**CITY OF CHESTERFIELD
PLANNING AND ZONING COMMITTEE MEETING
THURSDAY, FEBRUARY 8, 2007
CONFERENCE ROOM 101
5:30 P.M.**

RE: **P.Z. 5-2005 Winter Wheat Place (Dollar Building Company)**: a request for a change of zoning from "NU" Non-Urban District to E-One Acre for a 4.0 acre tract of land located on Winter Wheat Road, 3000 feet southeast of the intersection of Wild Horse Creek Road and Long Road. (18U220092)

DATE: JANUARY 17, 2007
TO: CITY OF CHESTERFIELD PLANNING COMMISSION
FROM: ANNISSA G. MCCASKILL-CLAY
RE: P.Z. 5-2005 WINTER WHEAT PLACE ROAD SYSTEM

P.Z. 5-2005 Winter Wheat Place (Dollar Building Company): a request for a change of zoning from "NU" Non-Urban District to E-One Acre for a 4.0 acre tract of land located on Winter Wheat Road, 3000 feet southeast of the intersection of Wild Horse Creek Road and Long Road. (18U220092)

8. Clarify the subdivision map. Explain the map section surrounding area "129" where the City boundary line is.

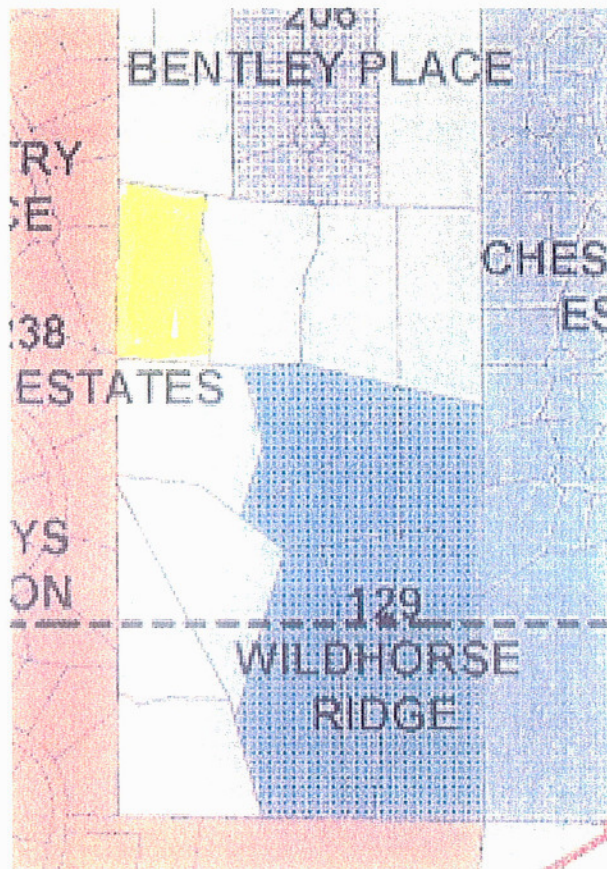
- ♦ What does "129 Wildhorse Ridge" stand for?
- ♦ Research whether "Wildhorse Ridge" refers only to the areas over "129".
- ♦ What do the dotted lines denote on the map?

Petitioner's Response:

8. Clarify the subdivision map. Explain the map section surrounding area "129" where the City boundary line is.

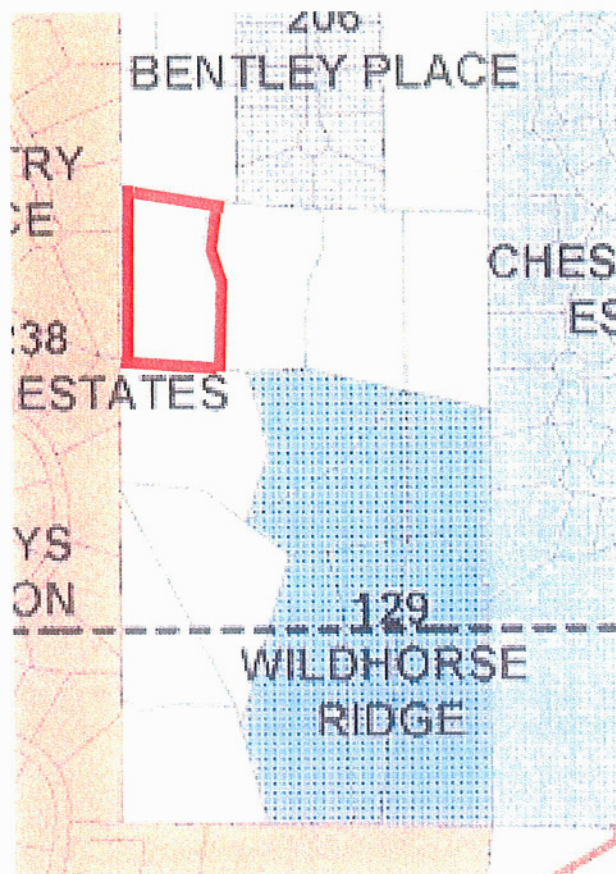
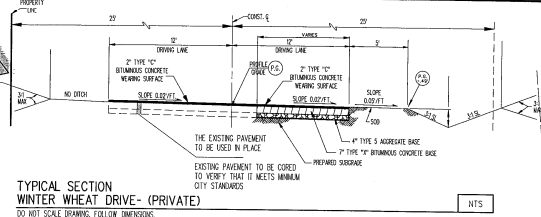
- ◆ What does "129 Wildhorse Ridge" stand for?
- ◆ Research whether "Wildhorse Ridge" refers only to the areas over "129".
- ◆ What do the dotted lines denote on the map?

Petitioner's Response: It is not part of *Wildhorse Ridge Subdivision* or any other subdivision.

Staff Response: The City of Chesterfield Subdivision map is drawn to show properties according to recorded plats. As shown in Exhibits 3 and 4, the subject site was not platted as a part of Wildhorse Ridge Subdivision.
